# Recall Bulletin

**SUBJECT:** Ignition Lock Cylinder Binding

**MODELS:** 2011-2012 Cadillac Escalade, Escalade ESV, Escalade EXT  
2011-2012 Chevrolet Avalanche, Silverado, Suburban, Tahoe  
2011-2012 GMC Sierra, Yukon, Yukon XL

The Parts Information and Service Procedure sections have been revised. Replacement of the inflatable restraint steering wheel module coil retaining ring is required. Please discard all copies of bulletin 14696.

4064725

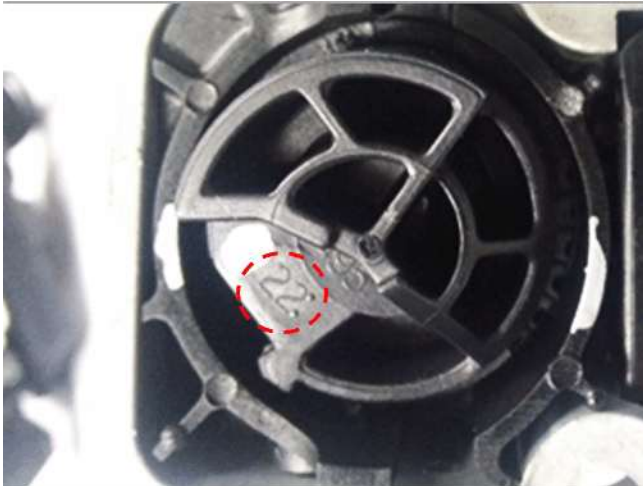
1. Remove the ignition lock cylinder case (1) from the steering column. Refer to Ignition Lock Cylinder Case Replacement in SI.

2. Inspect the inboard side of the housing for the mold cavity number, at the location shown circled in the graphic above:

- If the cavity number reads “22”, the ignition lock cylinder case MAY contain the failure issue and you should move directly to the Service Procedure below.
- If the cavity number reads anything other than “22”, the case can be reinstalled and no further action is required. For reinstallation, refer to Ignition Lock Cylinder Case Replacement in SI.

4064722

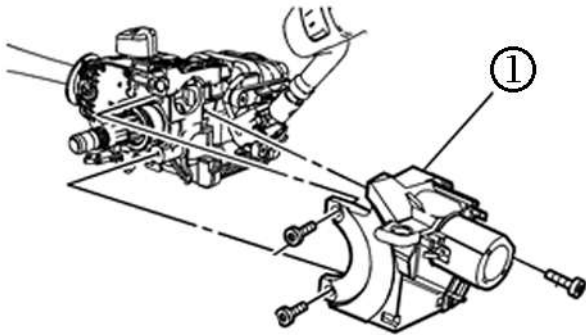
## Replace Ignition Lock Cylinder Case

1. Replace the ignition lock cylinder case with a new service part. Refer to Ignition Lock Cylinder Case Replacement in SI.
